ADDENDUM NUMBER 3

R18-01 Island Savings Centre Lobby Washroom Upgrades

January 25, 2018

Electrical Addendum E-03

E-1

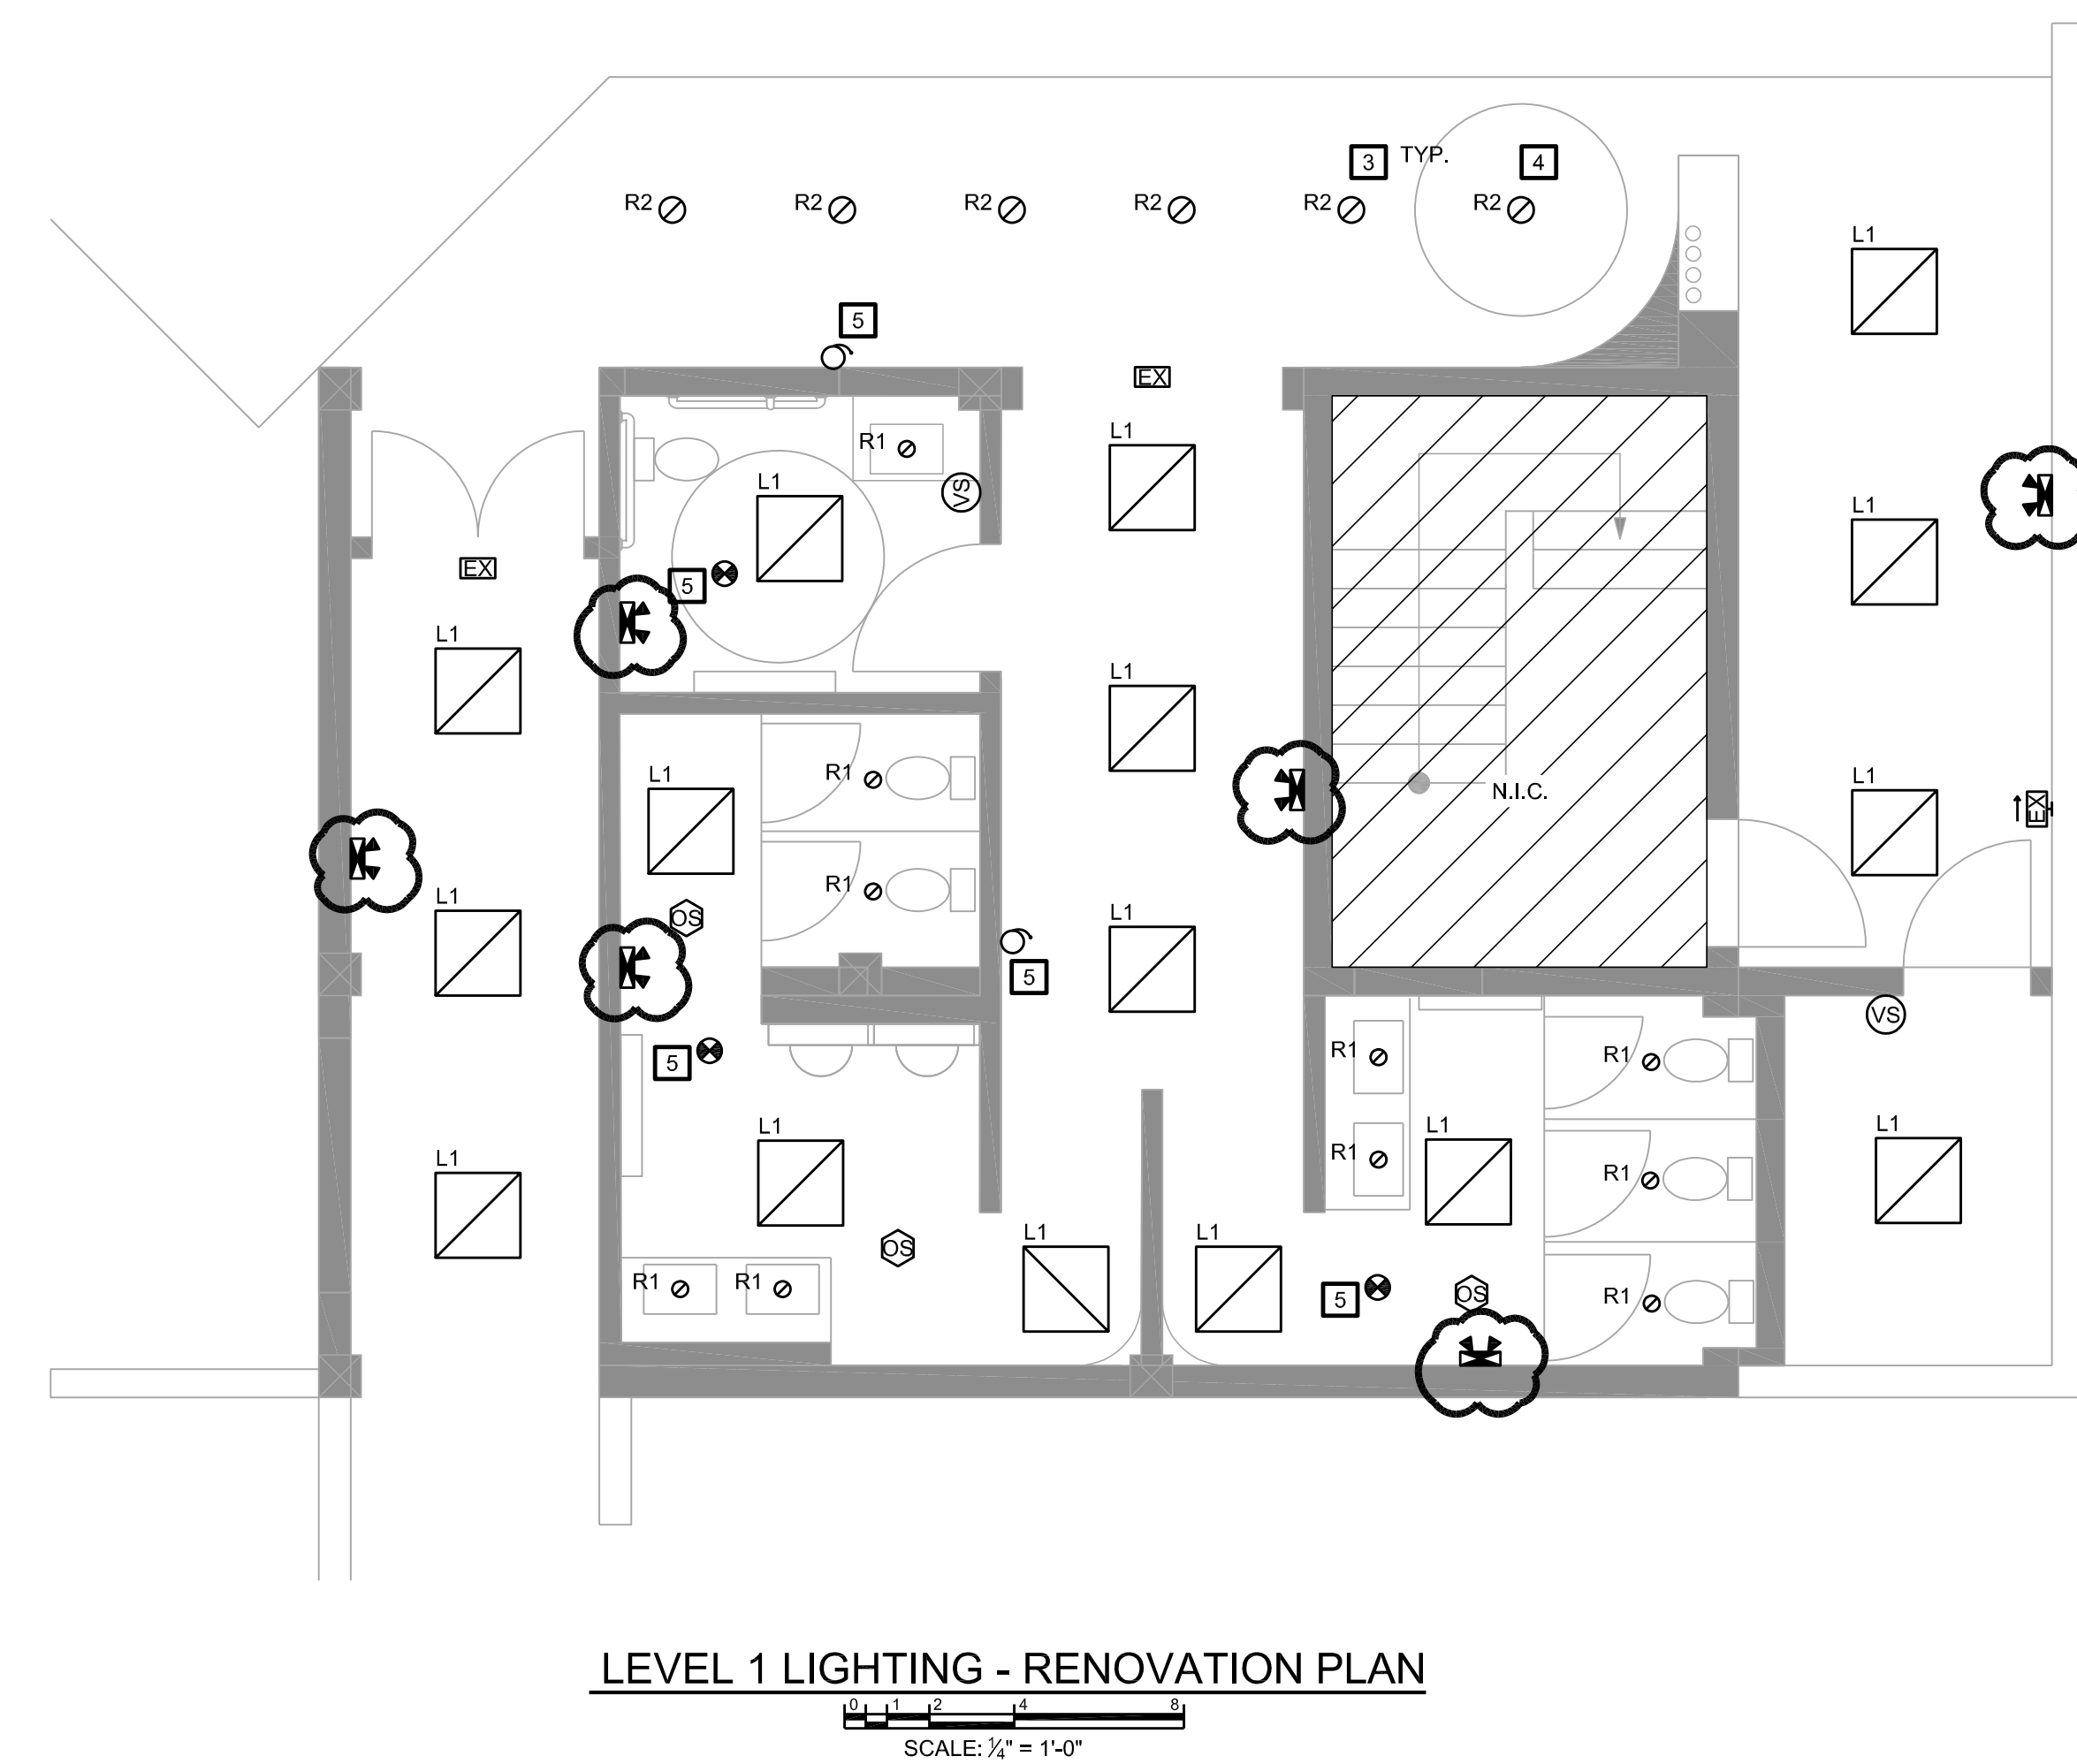
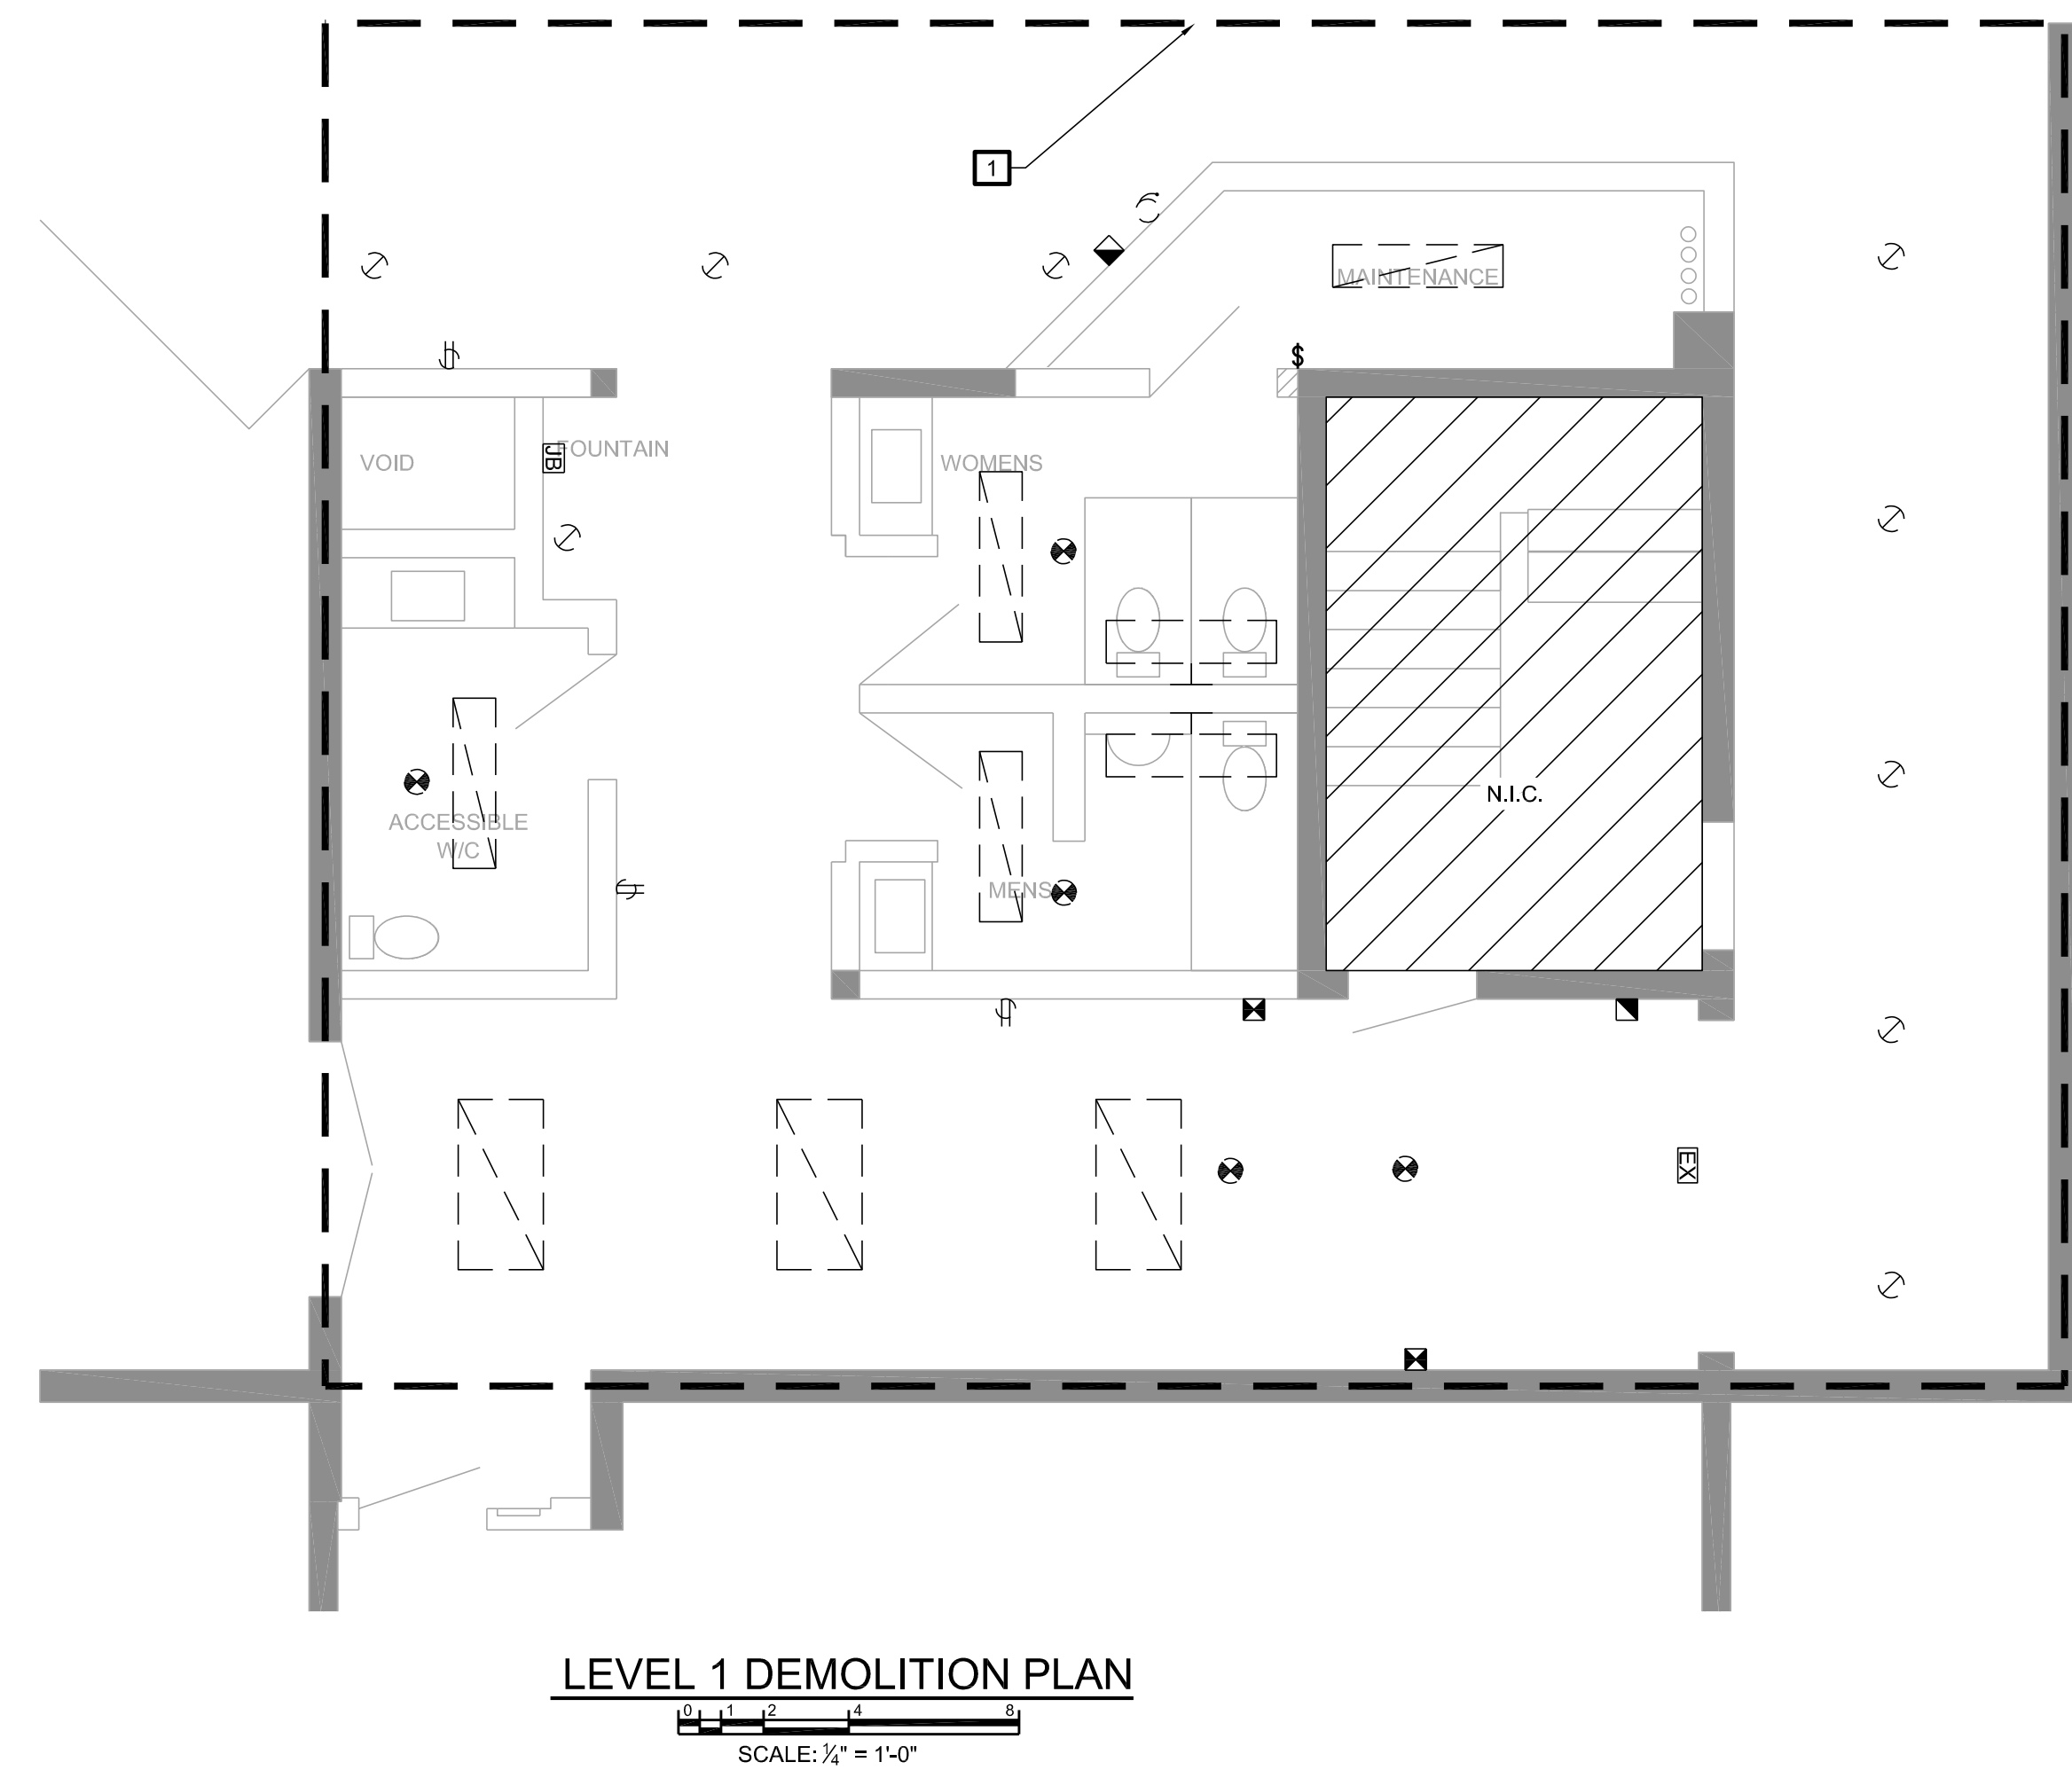
Q2. The electrical drawings don't seem to reflect any emergency lighting other than exits, are they required in the washrooms? Please provide all locations for emergency lighting.

Q3. While Addendum 2 does provide information/locations for the emergency exit lights, the location of "emergency battery pack lights" and their locations are not shown on the drawing. The assumption would be that emergency lighting would be required in each of the washrooms, washroom corridor and back corridor. Please provide clarity for these locations.

- 1.1 **REVISE** fire alarm system specification. See attached drawing E-0
- 1.2 **ADD** emergency lights to washrooms and corridors. See attached drawing E-1

A2. [See Electrical Addendum E-3.](#)

A3. [See Electrical Addendum E-3.](#)
